66309B-07

S E R V I C E N O T E

Agilent 66309B DC Power Supply

On faster computers, when programming over GPIB, a random error will occur.

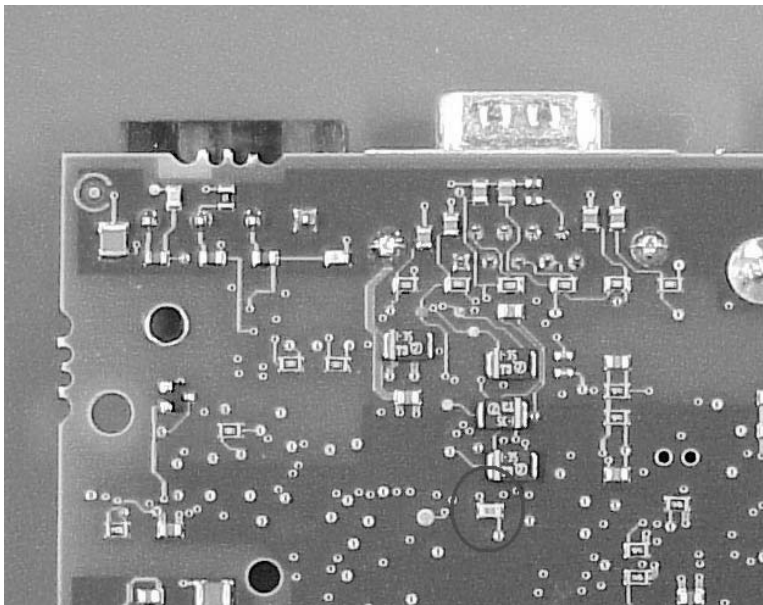
When programming a unit over GPIB, a random error -113 (“Undefined header”) will appear on the unit. This error can be read back via the front panel or over the GPIB bus.

Change resistor R1246 (see picture for location) from 511 Ohms to 100 Ohms (part number 0699-3058). This requires soldering a surface mount component and can be very difficult. This does not require re-calibration.
